Request for Information Response

RFI Number: R-AW071

ARAPAHO ROAD - PHASE III
 SURVEYOR BOULEVARD TO ADDISON ROAD
 PAVING PLAN AND PROFILE
 STA 75+00 TO STA 80+00

TOWN OF ADDISON, TEXAS

SECTION E - E

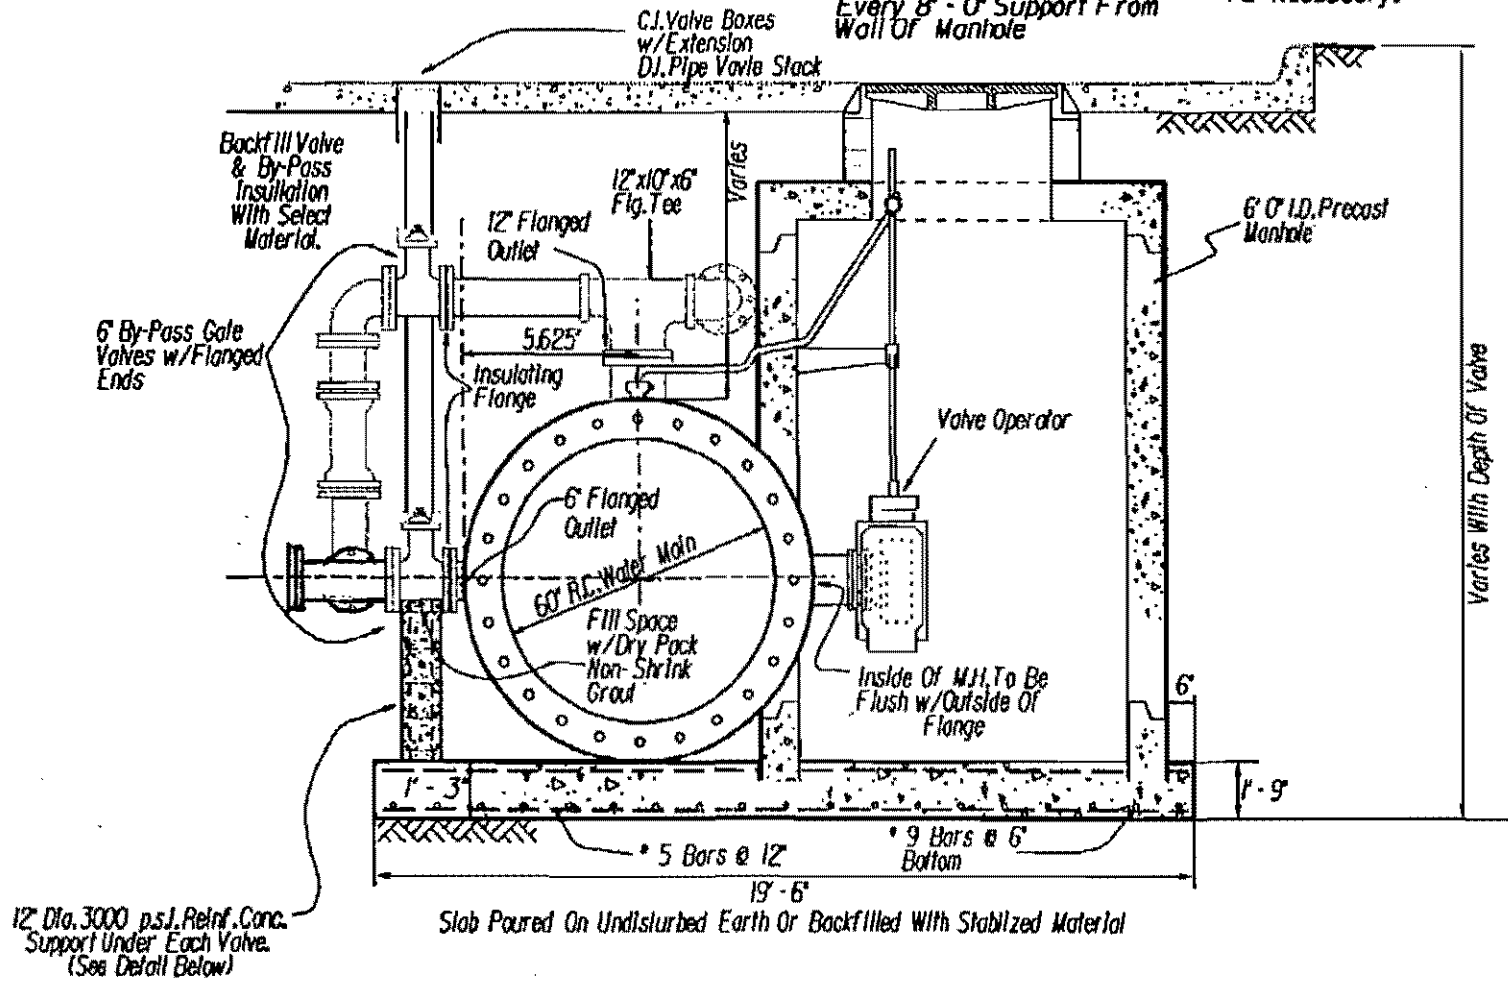
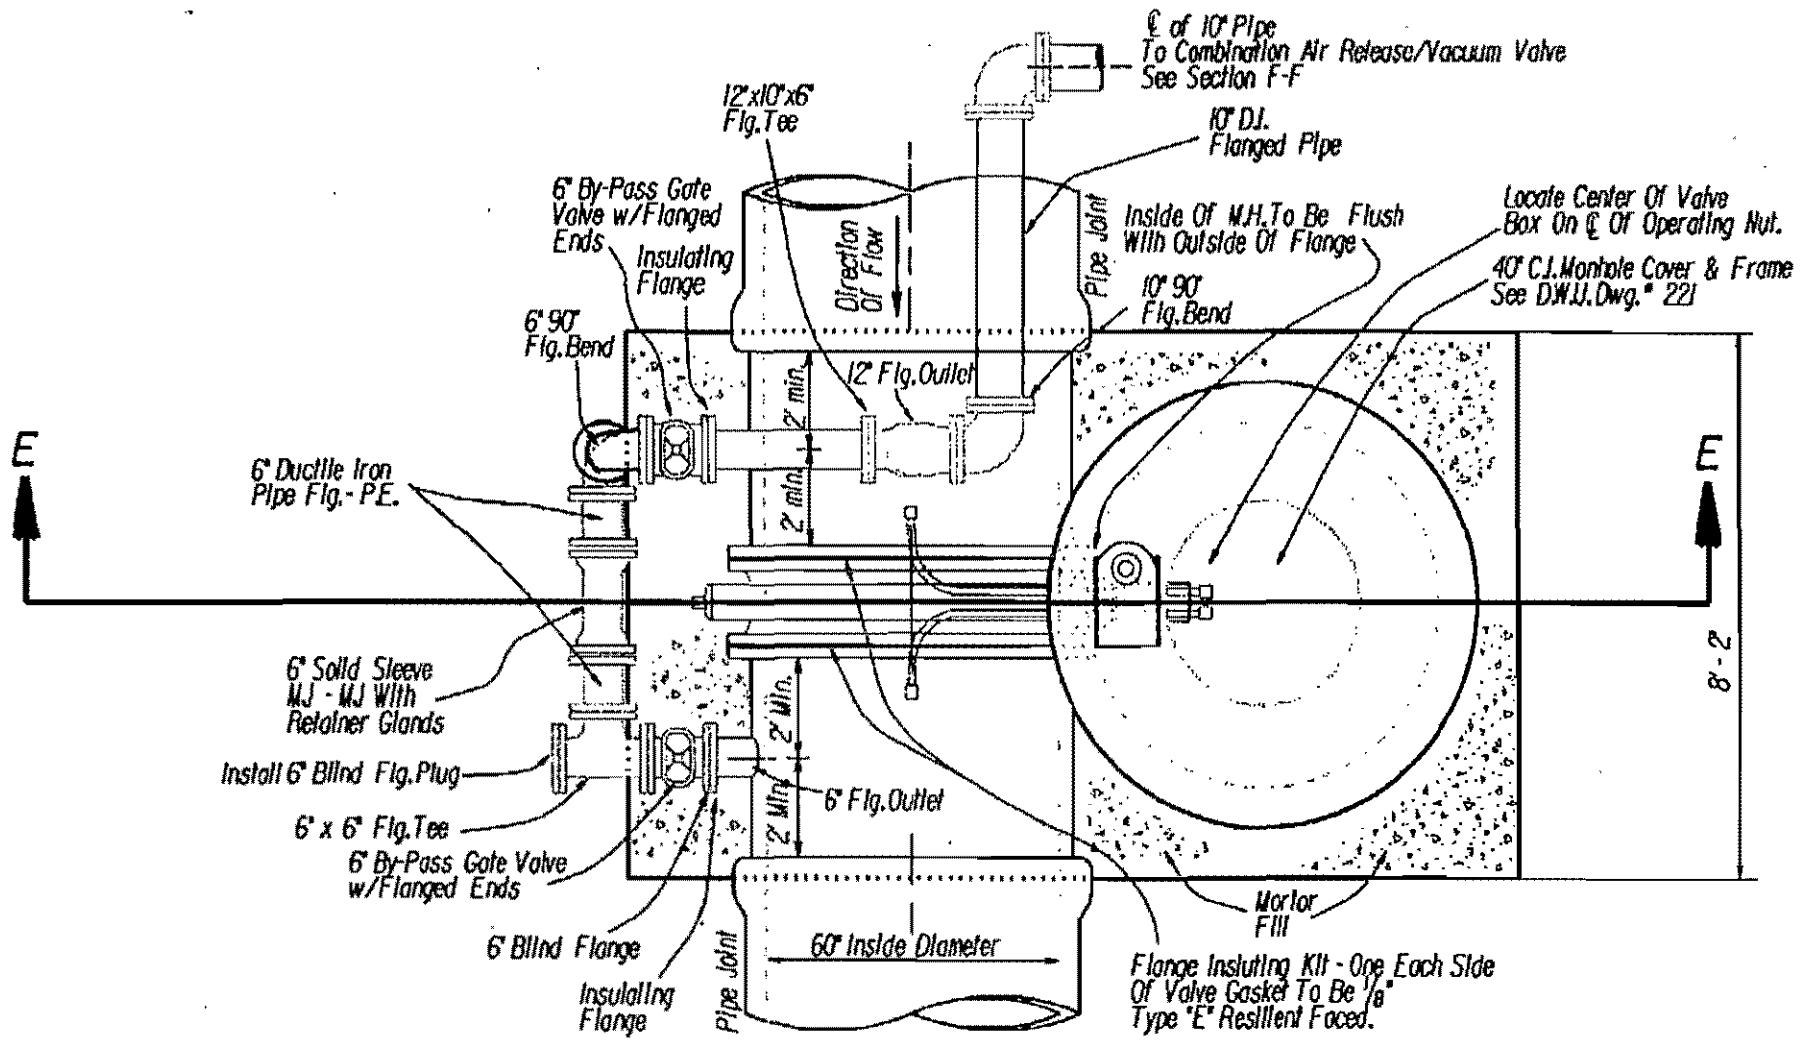
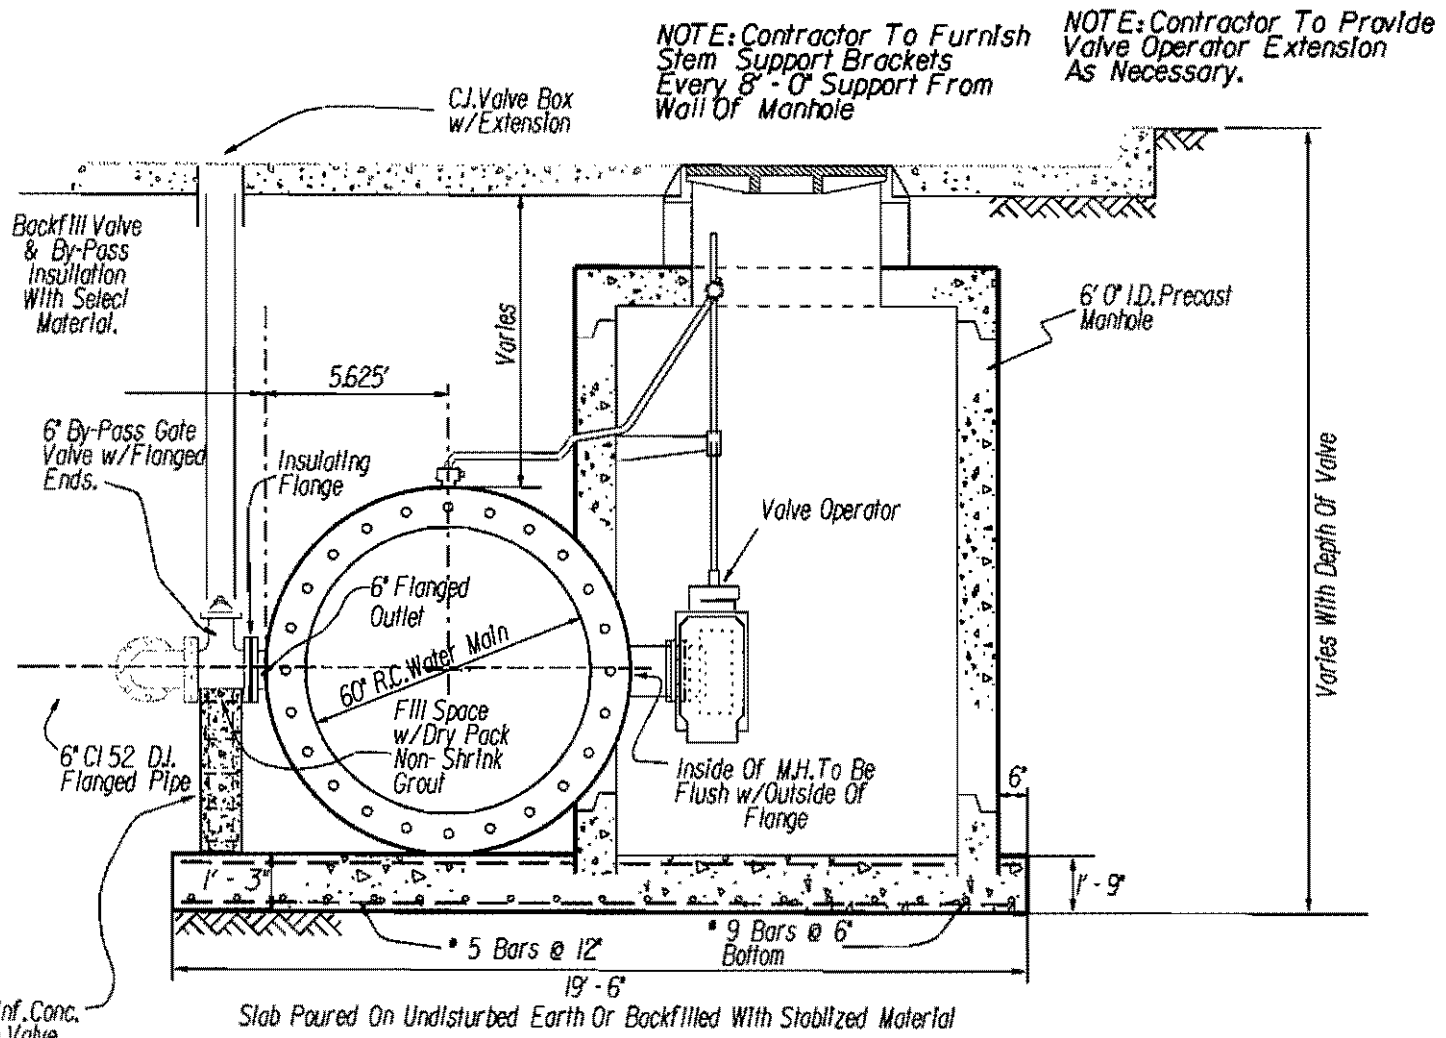
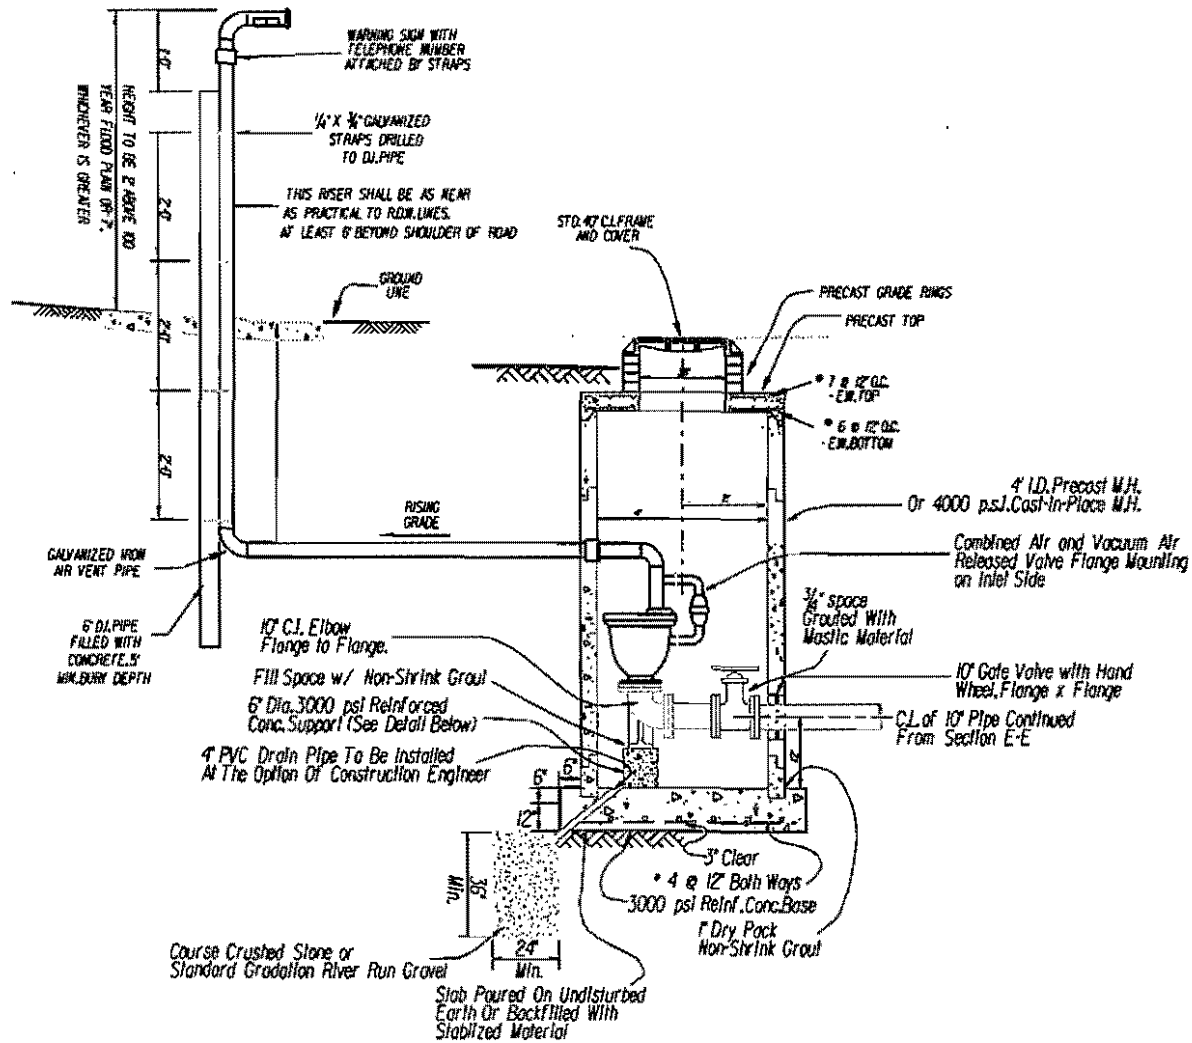
A/W received revised blow off details from HNTB on 3/9/05. We are pricing and proceeding with this revised detail. A/W is also proceeding with the pricing and installation of the 3" Air Release Valve per HNTB direction.

# of Copies	Drawing #	Last Dated	Code	Description
1	Plan View	3-8-05		Replacing Plan Detail on Dwg. DWU-1, page 118A
1	Section E - E	3-8-05		Replacing Section View Detail on Dwg. DWU-1, page 118A
1	Section F - F	3-8-05		New Section View Detail for 10" Air Release System
